ADDENDUM NO. 4

DESIGNER: D. GEISSERT	 STATE OF CONNECTICUT DEPARTMENT OF TRANSPORTATION	PROJECT TITLE: CHURCH STREET SOUTH EXTENSION OVER NEW HAVEN INTERLOCKING AND RAIL YARD	TOWN: NEW HAVEN	PROJECT NO.:
DRAFTER: M. OFFENBERG		CADD FILE: AD4R703S001.DGN	DRAWING TITLE: GENERAL PLAN - SHEET 1 OF 2	PROJECT NO.: 92-526
CHECKED BY: A. MORETTI	ENGINEER: PARSONS BRINCKERHOFF QUADE & DOUGLAS, INC.	PLOTTED DATE: 12-8-00	SHEET NO.:	
DATE CHECKED: 4-9-00	APPROVED BY: <i>Anthony A. Moretti</i>		SHEET NO.: 136

PROJECT TITLE:
CHURCH STREET SOUTH EXTENSION
OVER NEW HAVEN INTERLOCKING
AND RAIL YARD

DRAWING TITLE:
WINGWALLS 2A & 2B AND
RETAINING WALL 101 - SHT. 3 OF 3

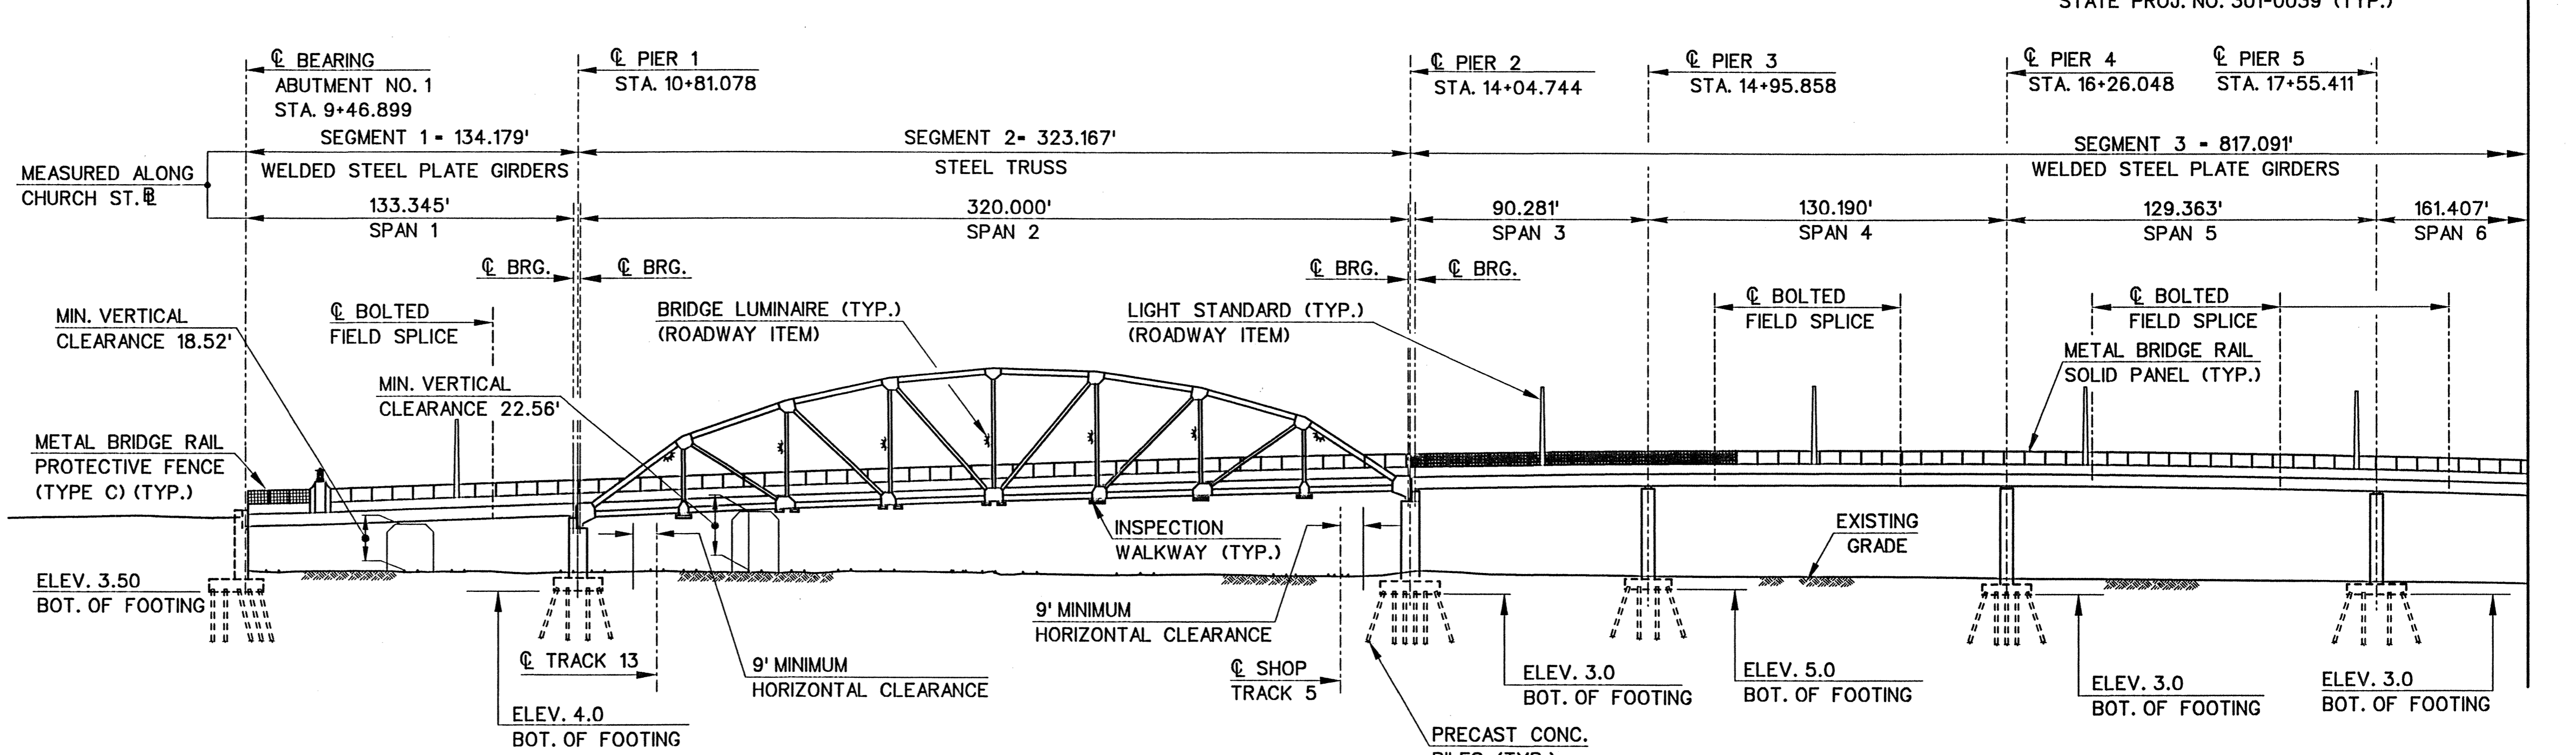
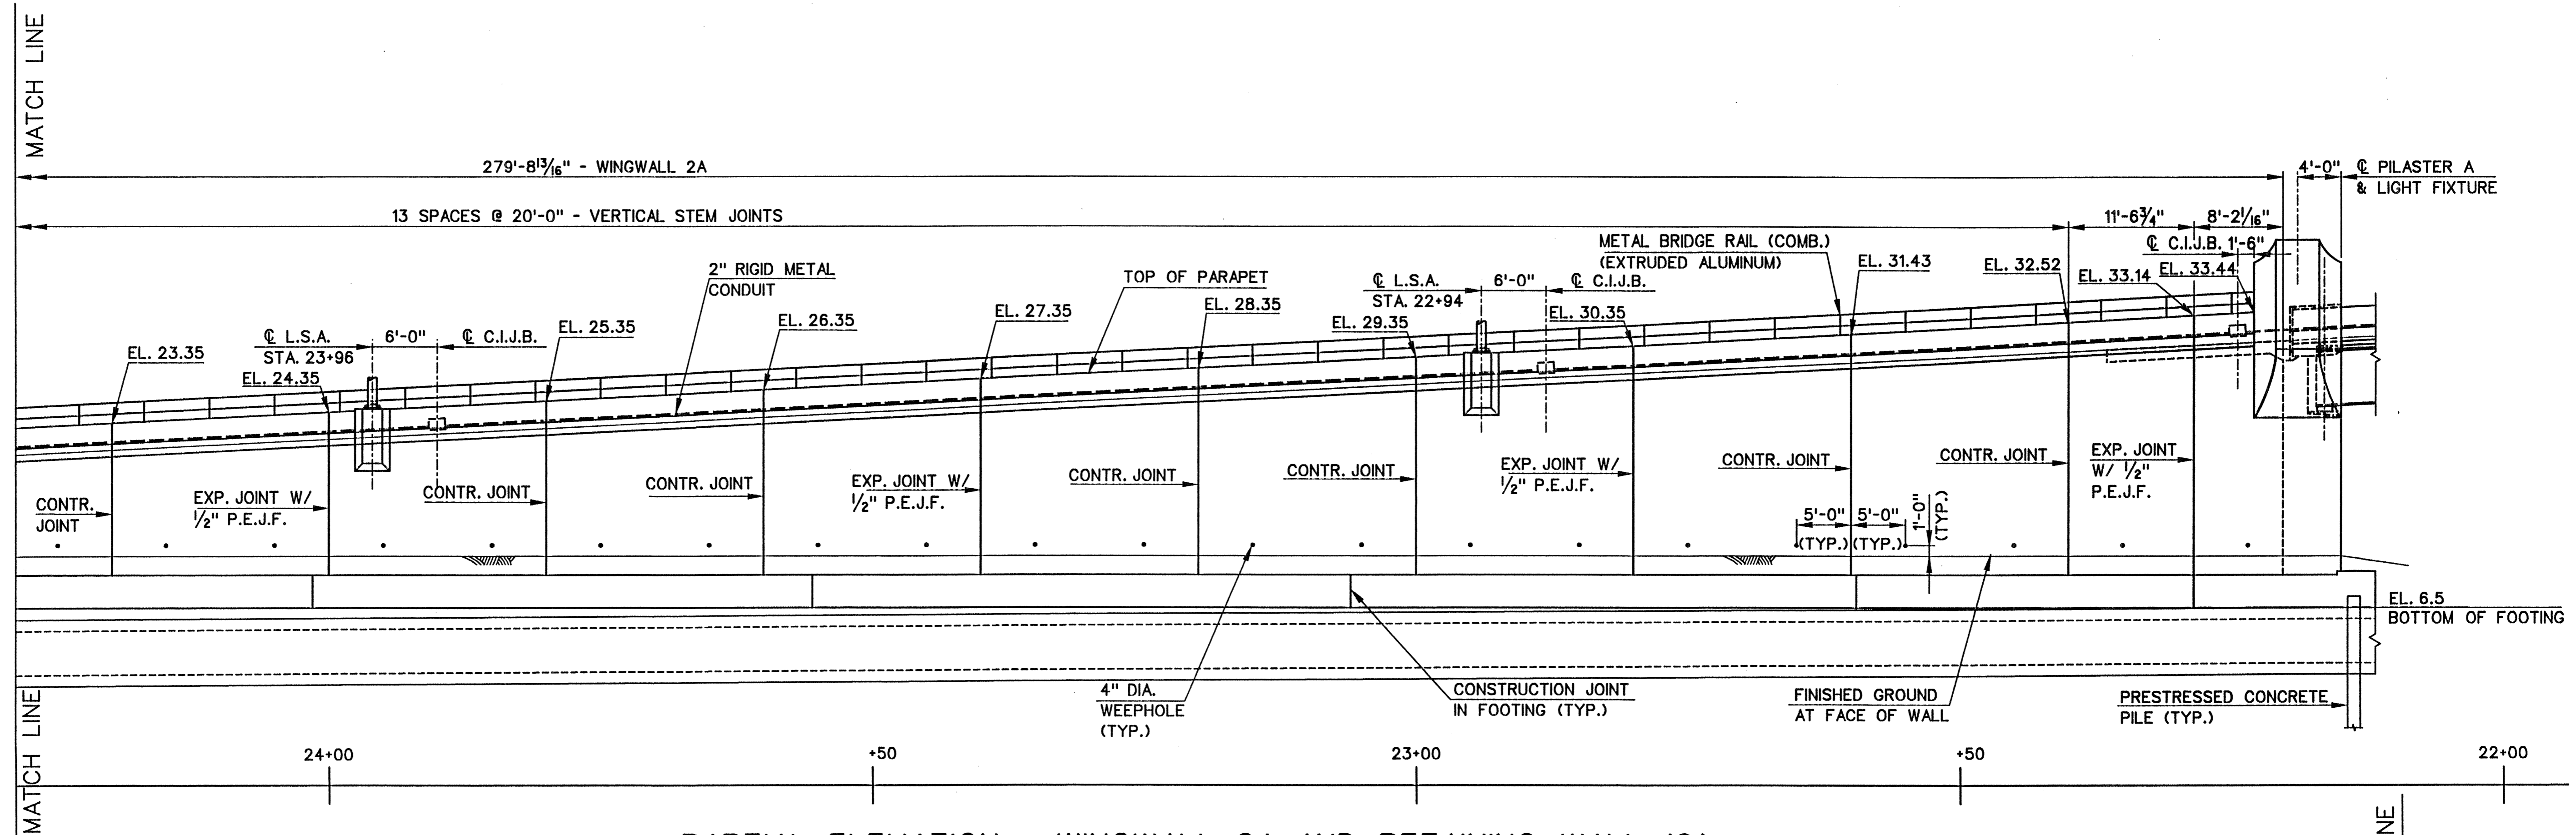
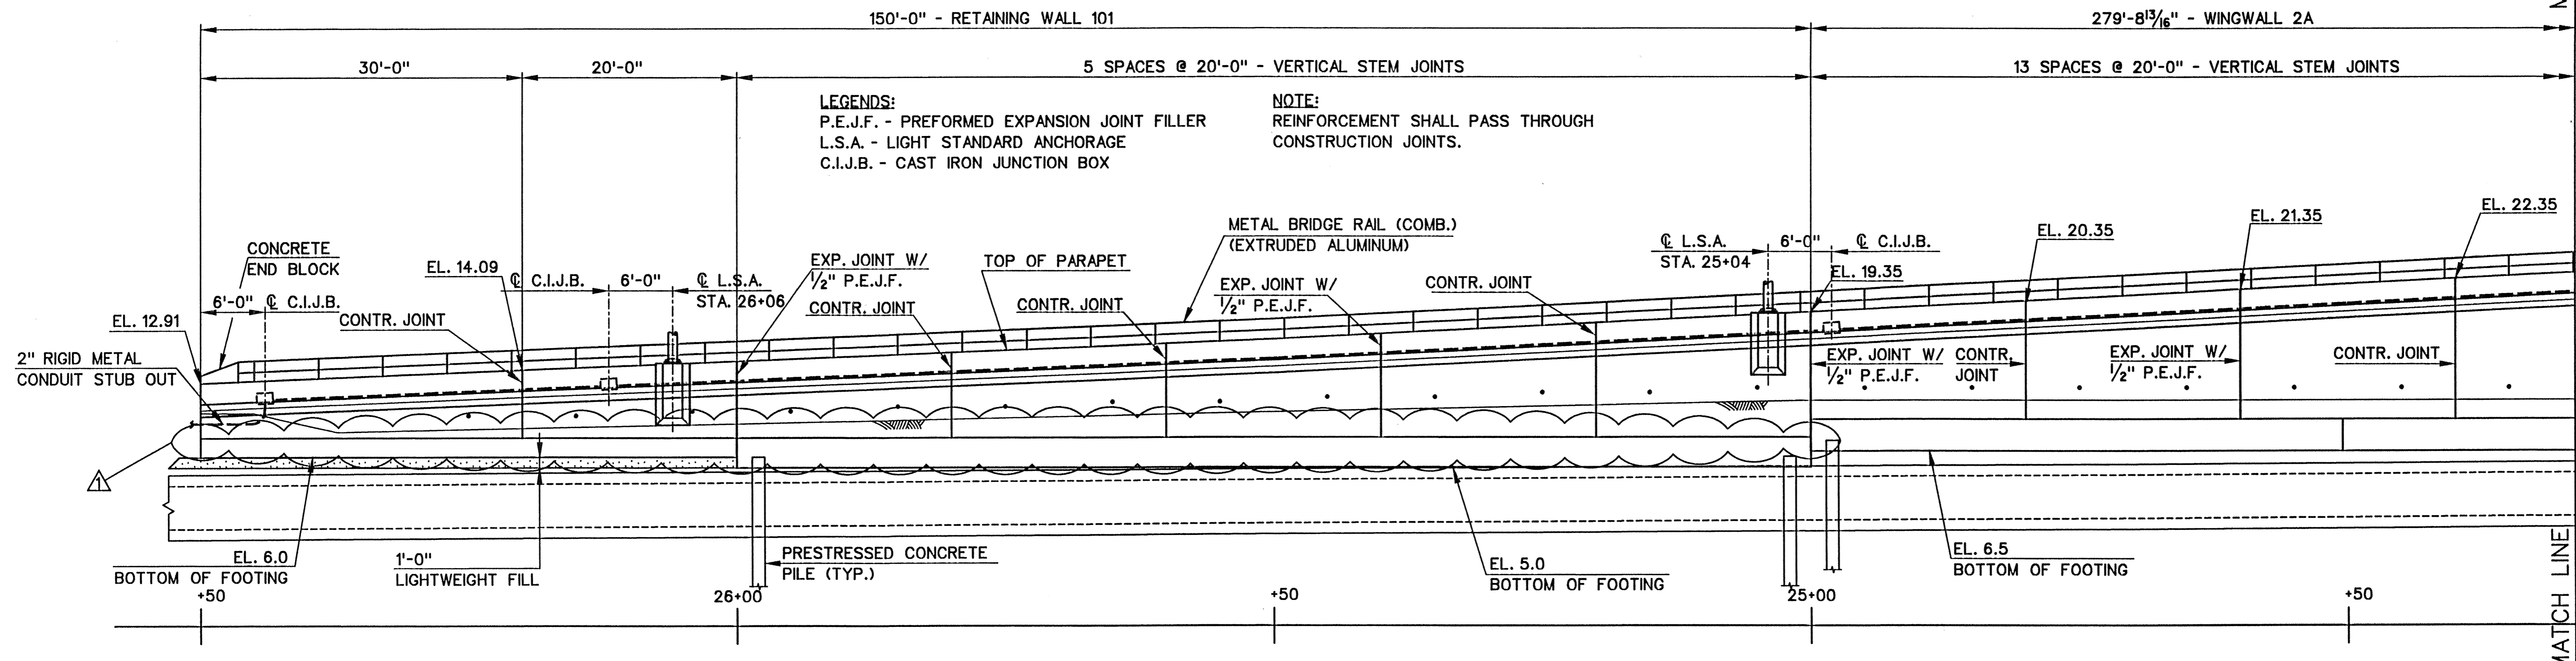
REV.	DATE	DESCRIPTION	REVISIONS	SHEET NO.
1	12-8-00	ADDENDUM NO. 4 - EXIST. FACILITIES REMOVAL		136

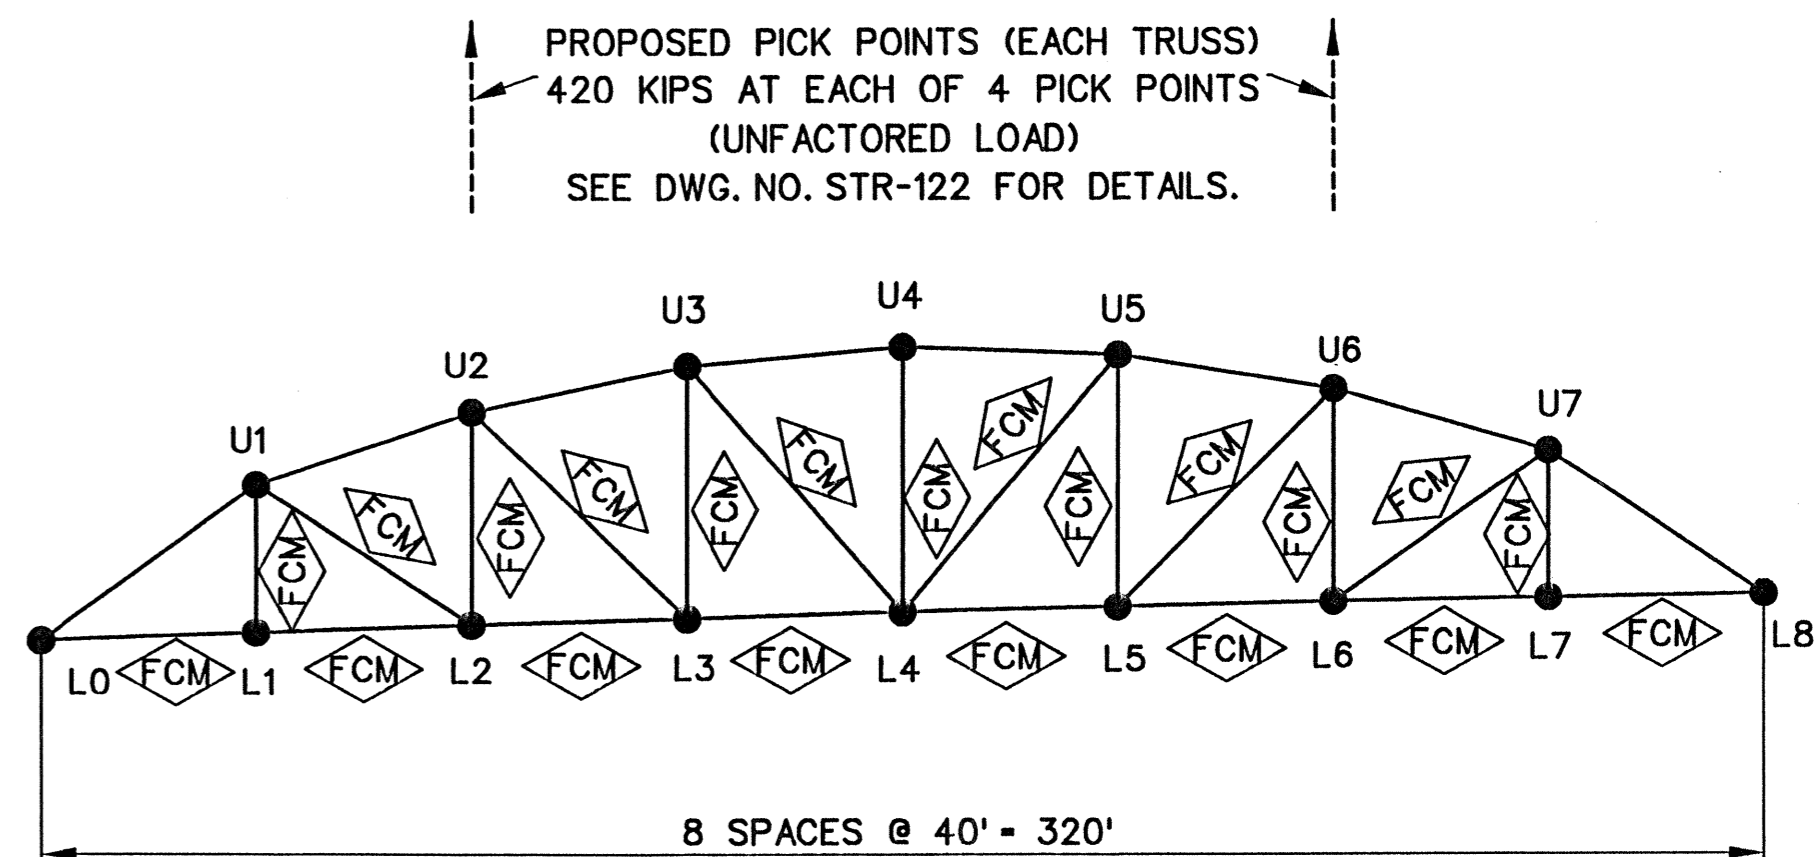
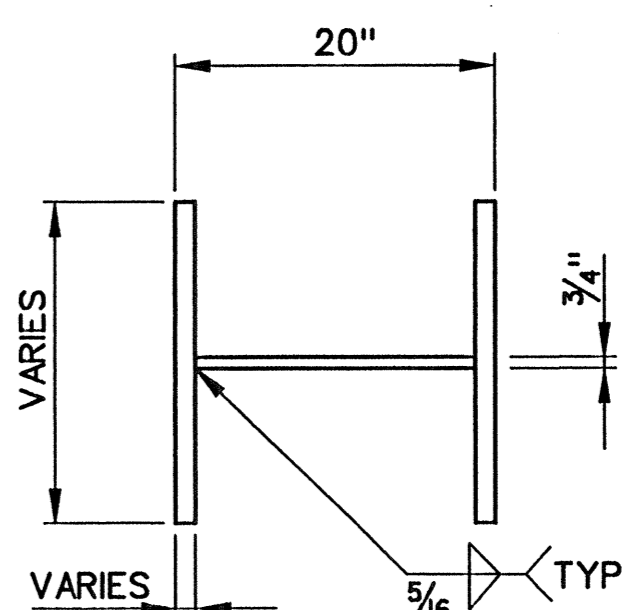
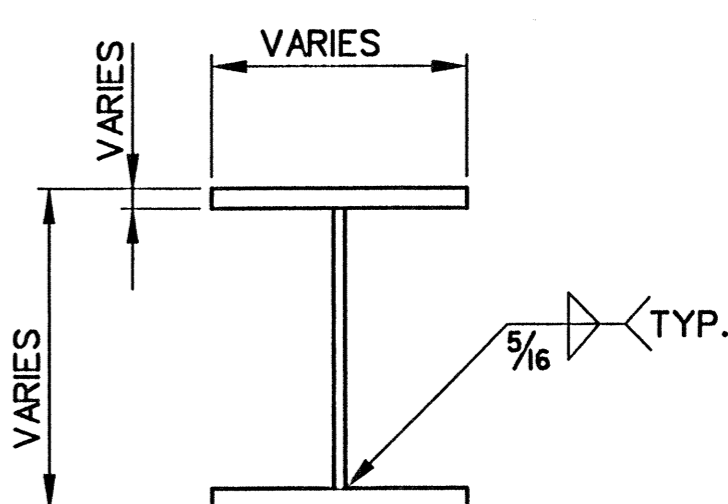
12-8-00 DATE	ADDENDUM NO. 4 - NOTE 4 ADDED.	198 SHEET NO.	DESIGNER: D. GEISSERT		PROJECT TITLE: CHURCH STREET SOUTH EXTENSION OVER NEW HAVEN INTERLOCKING AND RAIL YARD	TOWN: NEW HAVEN	PROJECT NO.: 92-526
			DRAFTER: M. OFFENBERG		ENGINEER: PARSONS BRINCKERHOFF QUADE & DOUGLAS, INC.	DRAWING TITLE: TRUSS SCHEDULE	DRAWING NO.: STR-64
			CHECKED BY: D. MOOLIN	DATE CHECKED: 4-9-00	APPROVED BY: <i>Ambly A. Moritz</i> DATE: 12/1/00		SHEET NO.: 198

- NOTES :
- THE STEEL DEAD LOAD DEFLECTIONS (STEEL D.L.) ARE DUE TO ALL STEEL WHICH INCLUDES ALL TRUSS MEMBERS, BRACING, STRINGERS, FLOOR BEAMS AND DIAPHRAGMS.
 - ADDITIONAL DEAD LOAD DEFLECTIONS (ADDITIONAL D.L.) ARE DUE TO THE UTILITIES, REMAIN-IN-PLACE FORMS, INSPECTION PLATFORMS AND THE CONCRETE SLAB.
 - THE COMPOSITE DEAD LOAD DEFLECTIONS (COMPOSITE D.L.) ARE DUE TO THE SIDEWALKS, PARAPETS, FUTURE BITUMINOUS WEARING SURFACE AND RAILINGS.
 - ALL STEEL MEMBERS IN SEGMENT 2 SHALL BE GRADE 50, UNLESS NOTED OTHERWISE.
